802.3dj D3.0

Comment Resolution

Optical Topics

Figure 180-10—TDECQ reference equalizer functional model

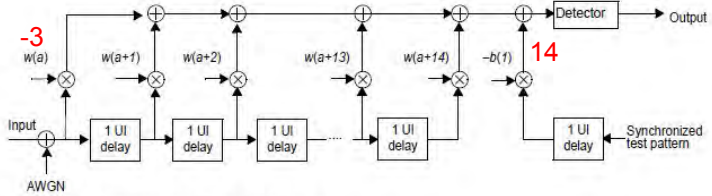
#465 Fix the main tap position e.g. at position 4, and add up to 3 more FFE taps as necessary to preserve the FFE's effectiveness. Remove the variable a in Figure 180-10
 □ change to the tap weight too?

No update needed for this comment

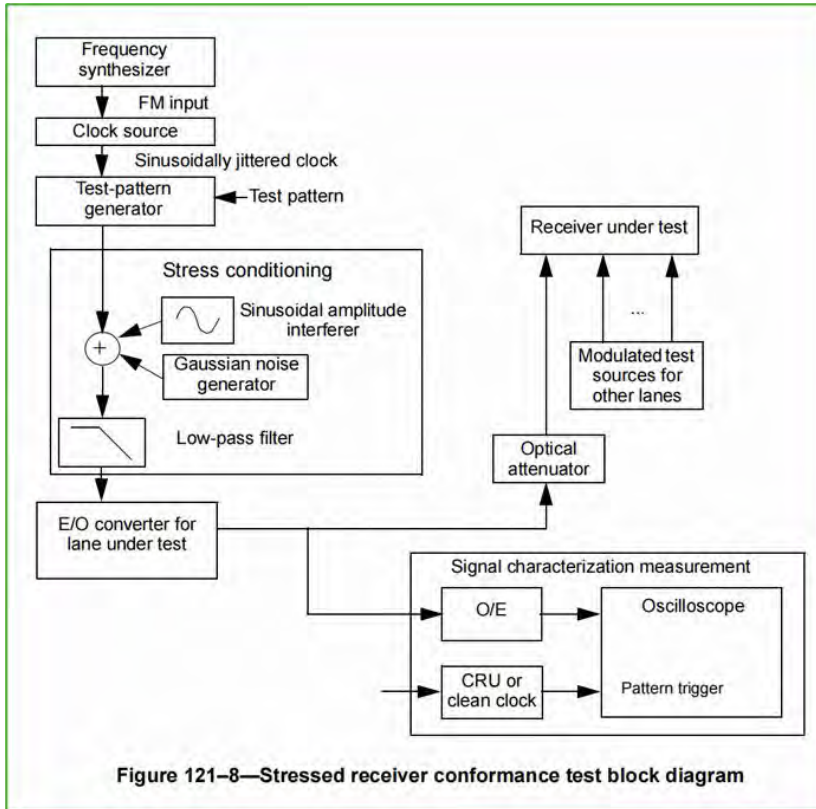
The frequency of the sinusoidal amplitude interferer in the stressed Rx test is not specified. If its period is significantly longer than a FEC code-word it will cause significant degradation in BLER for the same BER and TECQ due to it significantly increasing the probability of correlated errors

Add an additional exception at line 42. "- The frequency of the sinusoidal interferer is greater than 200MHz. Add the same exception to 181.9.16, 182.9.16 and 183.9.16

- The frequency of the sinusoidal interferer is greater than 200MHz.

Figure 180–7—Reference receiver block diagram

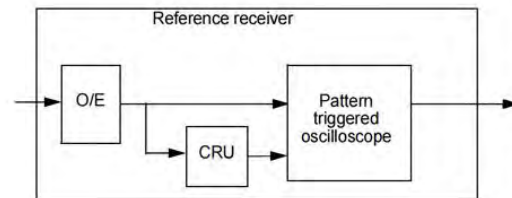
The choice of fourth-order Bessel-Thomson response is a historical accident. Fifth order rolls off a bit steeper at high frequencies, which is more realistic, and has no other significant difference. The better roll-off leads to better measurements. This is also true for measurements where reflections at an instrument's electrical connectors are a concern. This is our chance to make the change, as the industry transitions to a new speed and new test equipment.

Change fourth-order to fifth-order throughout the draft.

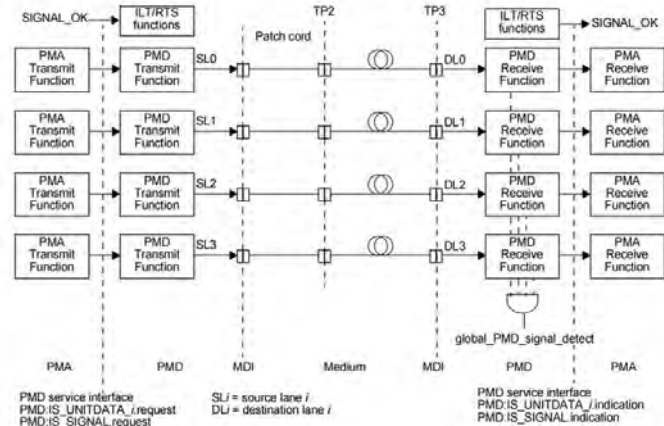
Sometimes this diagram is taken too literally leading to a belief that the 2 to 5 m patch cord and TP2 are part of a service link. They are not; optical cabling may include a variety of connectors (not the type used on test equipment), patch panels, and maybe optical switches, the length of any first patch cord is not regulated, and there may be no accessible TP2.

Either: remove TP2 from the medium, and show the patch cord and TP2 (connected to test equipment) as an alternate;
 or: at line 2 normative text, add: While TP2 and the patch cord for transmitter measurements and tests are shown in Figure 180-2, they are not part of the medium. The transmit MDI is connected to the medium for use, or to the patch cord and TP2 transmitter measurements and tests.

PROPOSED ACCEPT IN PRINCIPLE

Implement the second option, at line 2 normative text, add: While TP2 and the patch cord for transmitter measurements and tests are shown in Figure 180-2, they are not part of the medium. The transmit MDI is connected to the medium for use, or to the patch cord and TP2 for transmitter measurements and tests.

Implement with editorial license and over all optical clauses.

Figure 180–12—Transmitter functional test block diagram

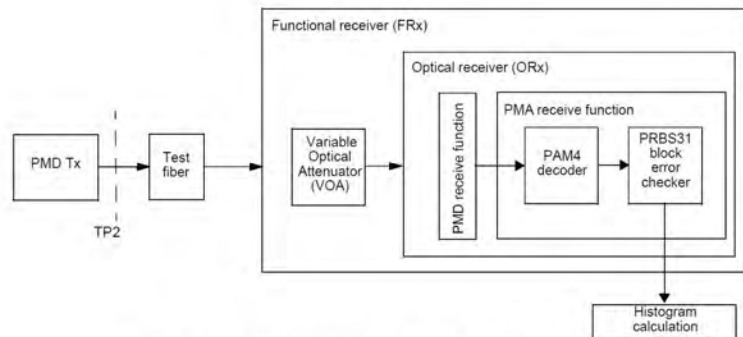
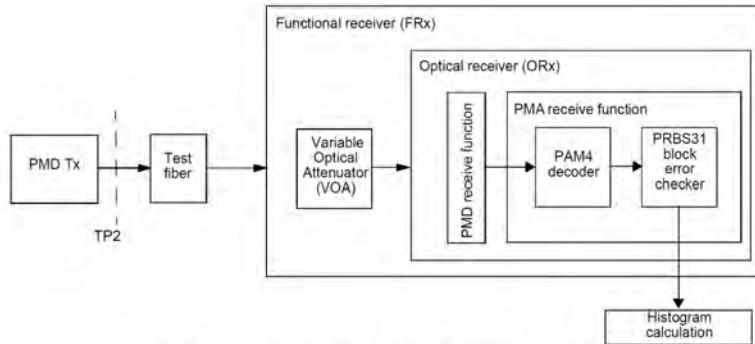
The Transmitter functional symbol error histogram (TFSEH) subclasses should be revised. A supporting presentation with the proposed changes for 180.9.9, 181.9.9, 182.9.9 and 183.9.9 will be provided.

Using "FRx" to mean "functional receiver" is very confusing, since FR is also used to indicate the 2 km CWDM PMD family, and "FRx" or "FRn" are commonly used to indicate a set of FR PHYs.

The transmitter functional test uses a functional receiver (FRx) defined in 180.9.9.1 to measure a transmitter functional symbol error histogram (TFSEH) defined in 180.9.9.2. A block diagram showing the functional receiver is shown in Figure 180–12. The transmitter under test is connected to the functional receiver by a test fiber which meets the requirements in 180.9.6.2. Full compliance with 180.9.6.2 requires the test fiber to provide back reflection with polarization state resulting in the greatest RIN. Other test fibers, including patch cords, may be used for additional tests.
